**PLANNING COMMISSION
THURSDAY, JUNE 3, 2021 6:00 PM**

1. Application #2021-5215; National Road SW; Applicant Joe Ciminello; Major Site Plan (Eastwood)
2. Application #2021-5214; National Road SW; Applicant Joe Ciminello; Preliminary Plat (Eastwood)
3. Application #2021-5083; 1122 & 1170 Lancaster Avenue; Applicant Laurie Gunzelman; Amendment of Development Plan (The Oliver)

RE: East Main – Major Site Plan #2021-5215 Staff Report

On behalf of the City of Reynoldsburg, EMH&T conducted a preliminary engineering review of the private development plan for the Eastwood project. The following summarizes our findings and recommendations with respect to this development.

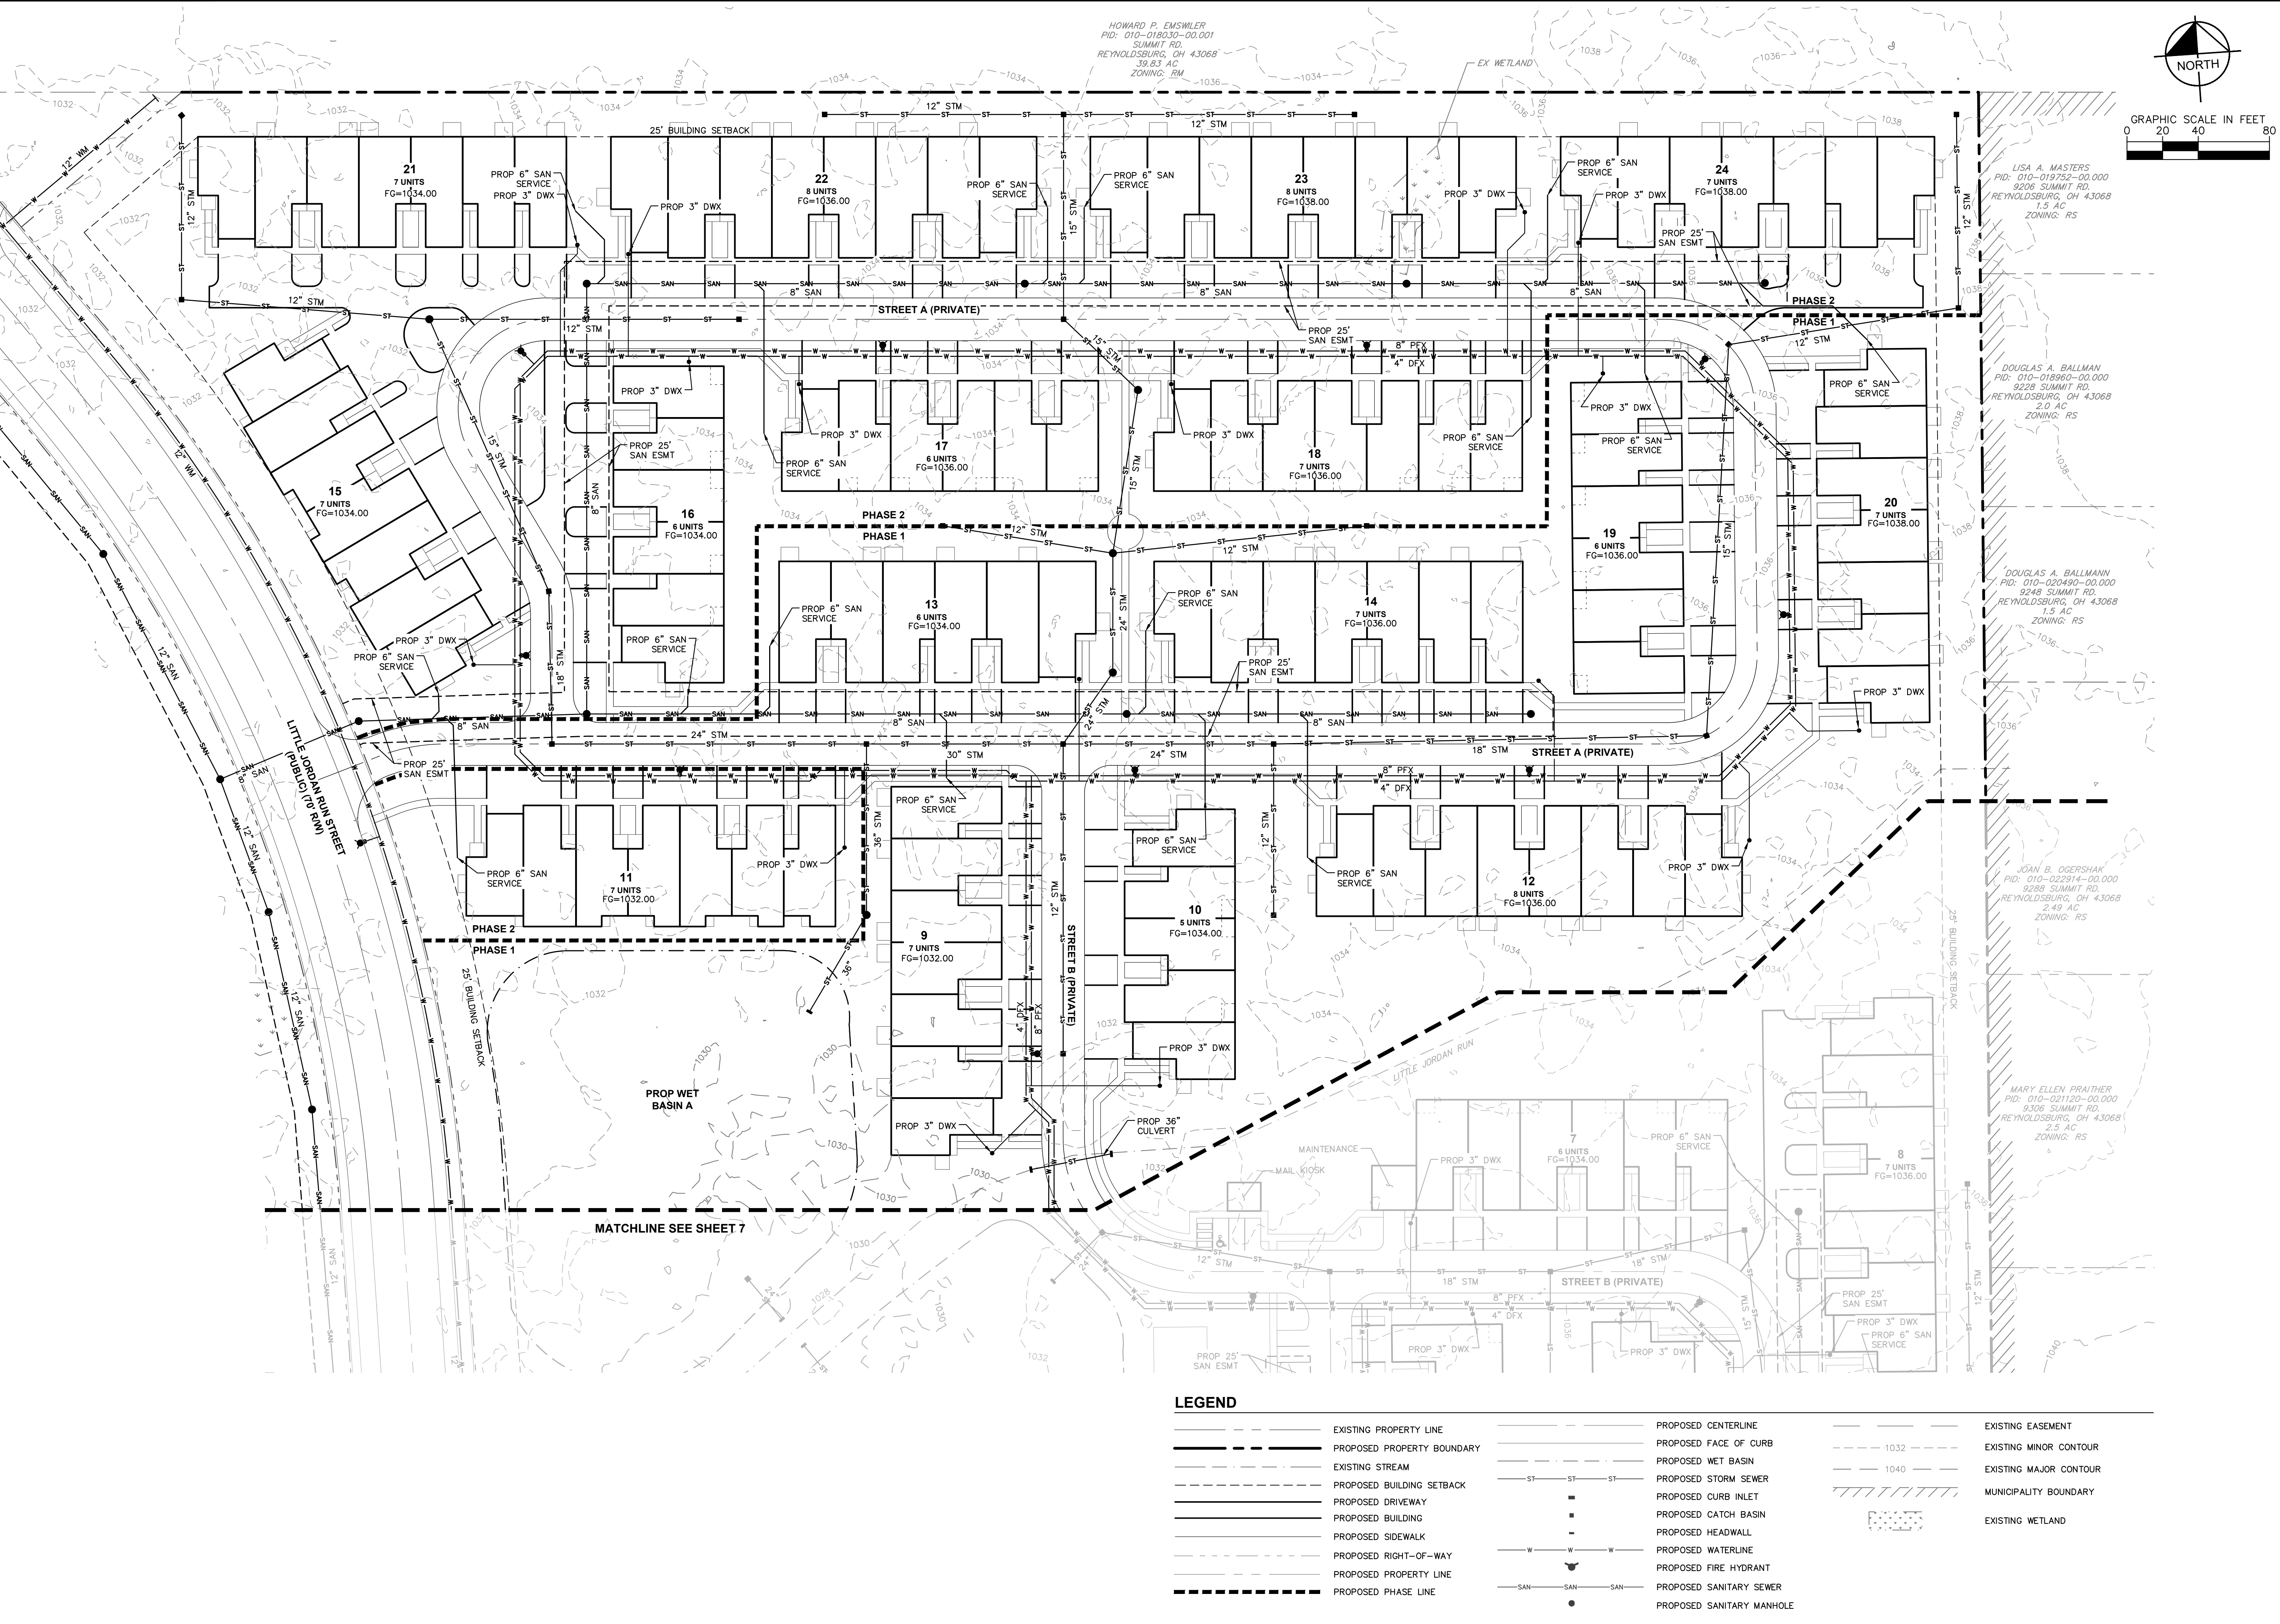
10. Submit sanitary calculations and tributary area map with the PGU.
 11. Please show extension of sanitary sewer to Lots 2 and 3.
 12. 12-in public water main is being extended through the site to allow for looping of the City's public water system.

13. Show hydrants and thrust blocks at the end of proposed water mains.
 14. 12" watermain along Eastwood Drive should continue along road's entirety and a stub left on the north side of E. Main Street.

16. The Utility Plan shows several 36-in pipe culverts in the locations where Little Jordan Run crosses the proposed roadways. This stream is assumed to be jurisdictional and therefore will require 401/404 permitting for these culverts. Additionally, calculations or modeling, which verifies the proposed pipe size must be submitted with the PGU. Also show the stream corridor protection zone (SCPZ) of the Little Jordan Run and demonstrate that the site plan does not impact it.

DD-16 SITE LIGHTING PLAN

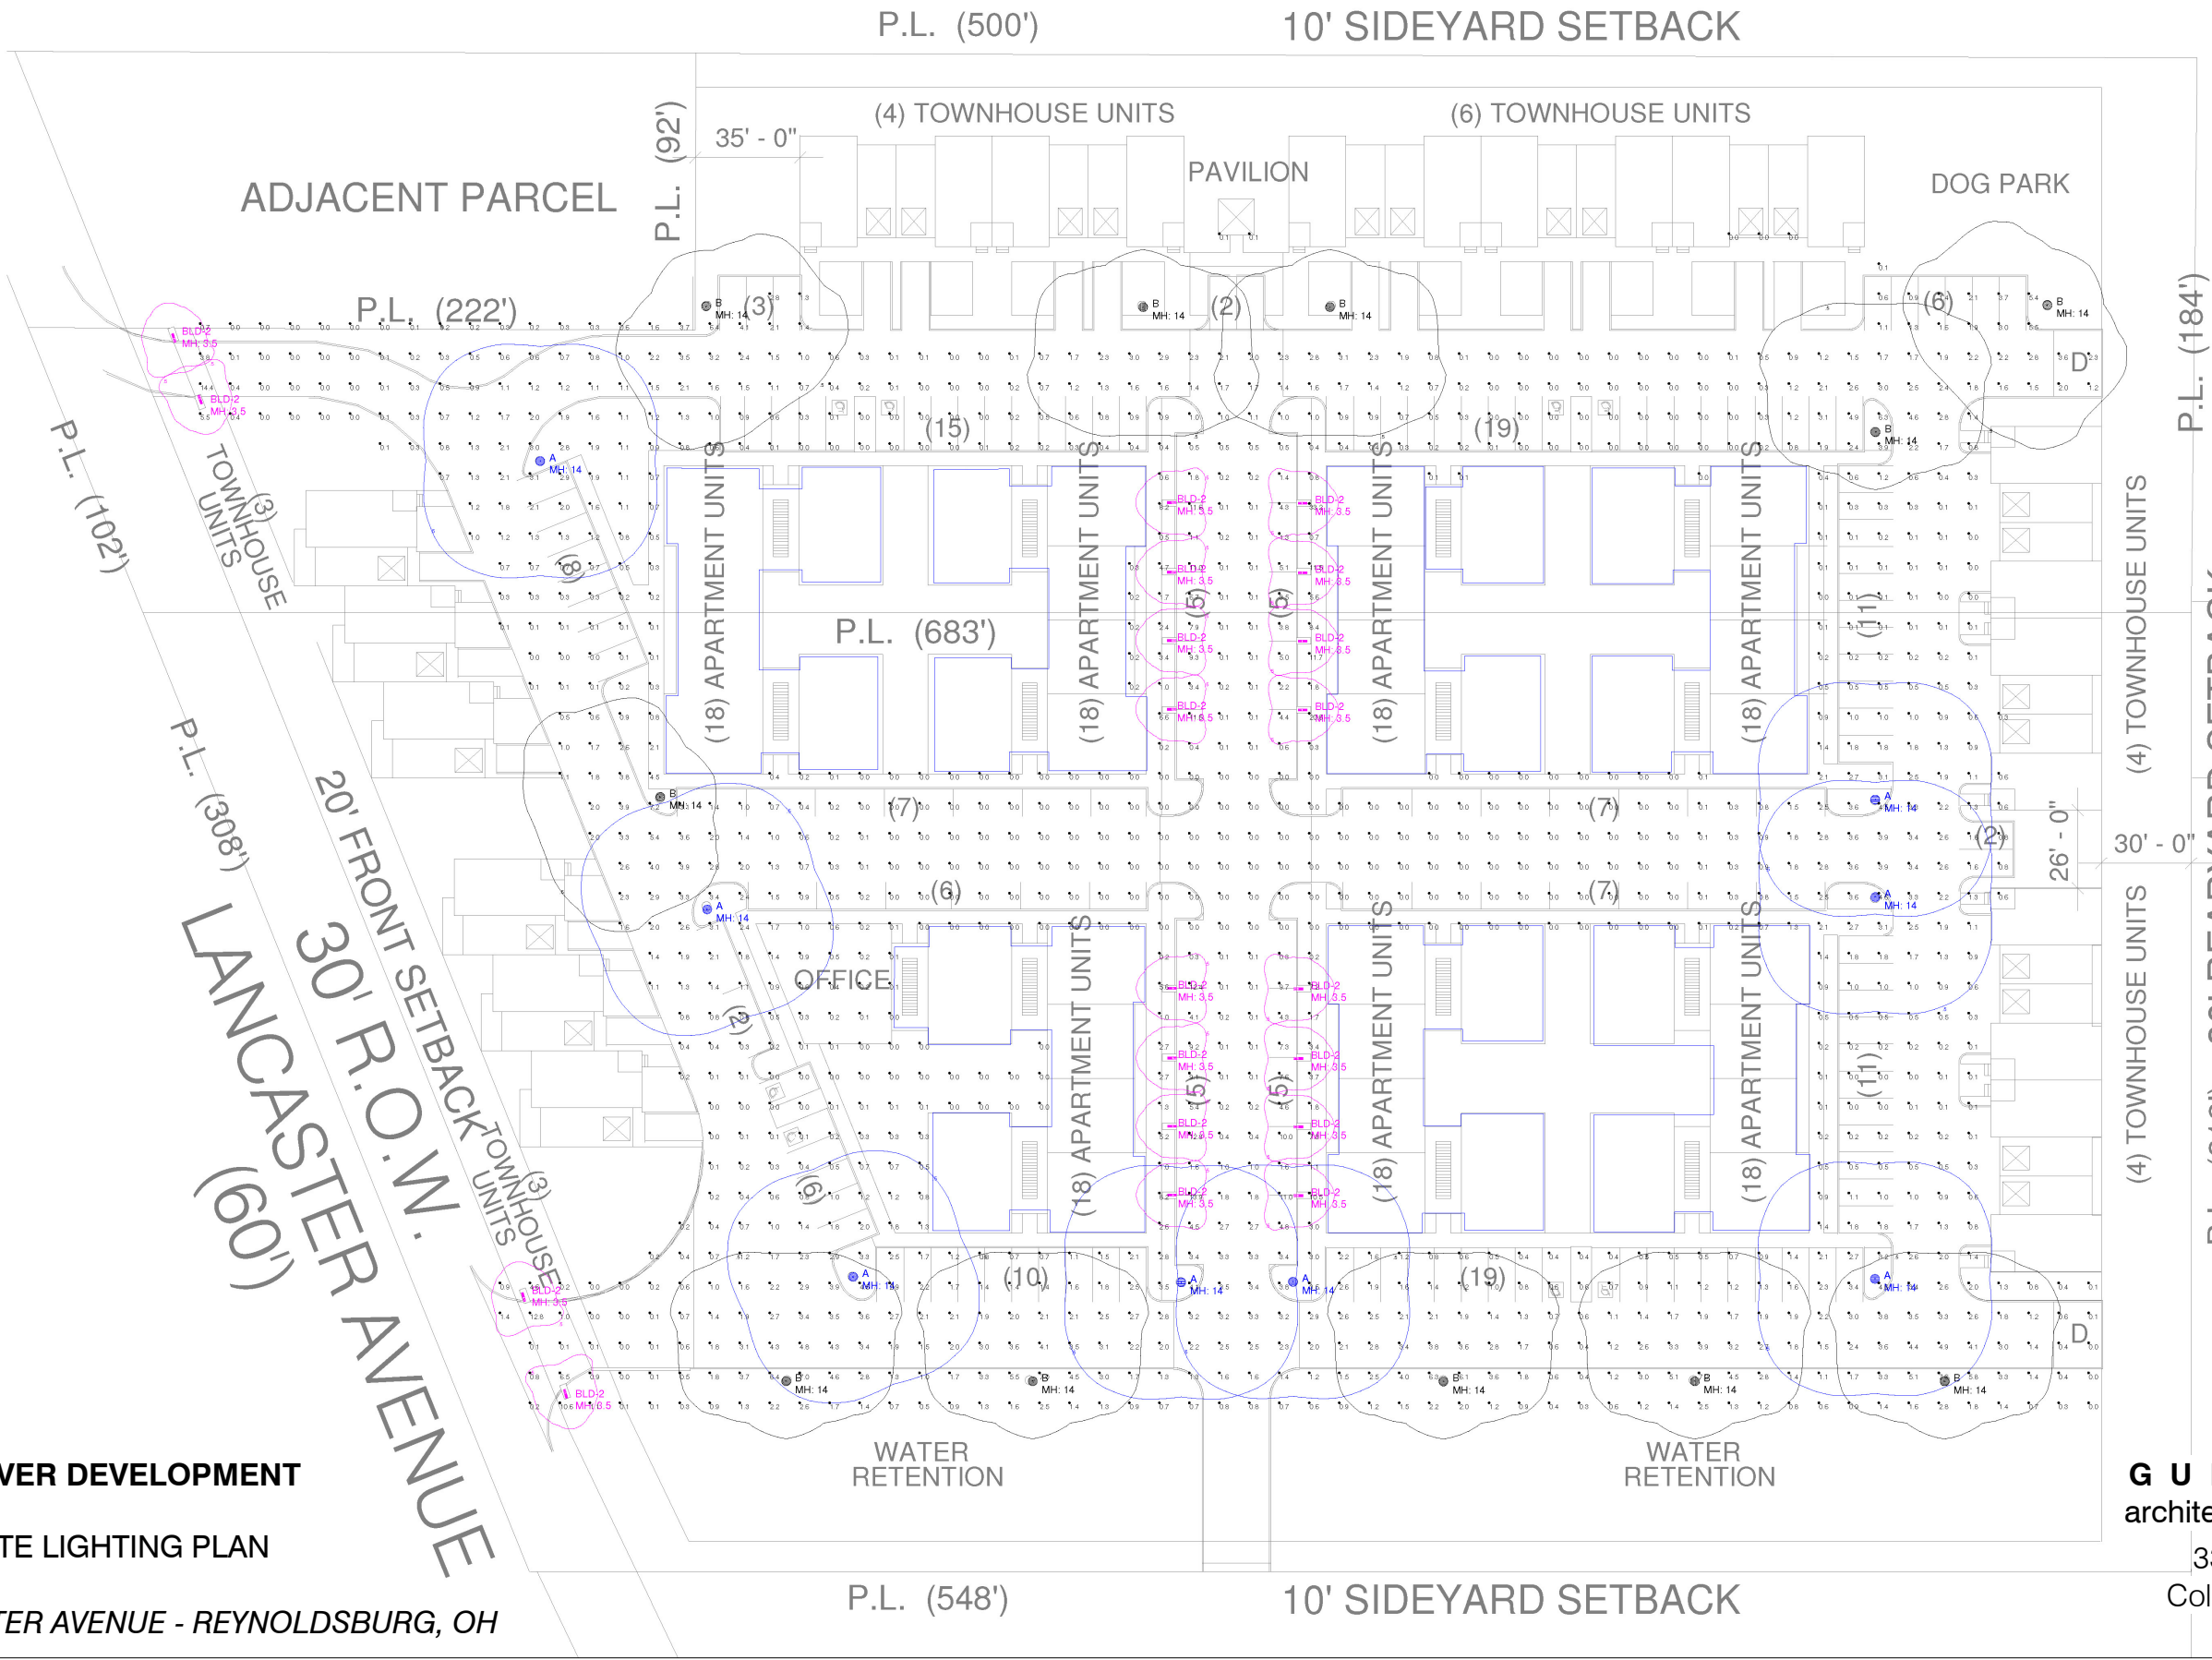
13. For lighting, the project is proposing a post-top style with an acorn style luminaire, similar to the City's standard drawing R-26. The submitted photometric analysis shows dark spots primarily on the interior of the site, but does provide adequate lighting at intersections. Will there be additional lighting or building lighting to provide light to the central portion of the site?
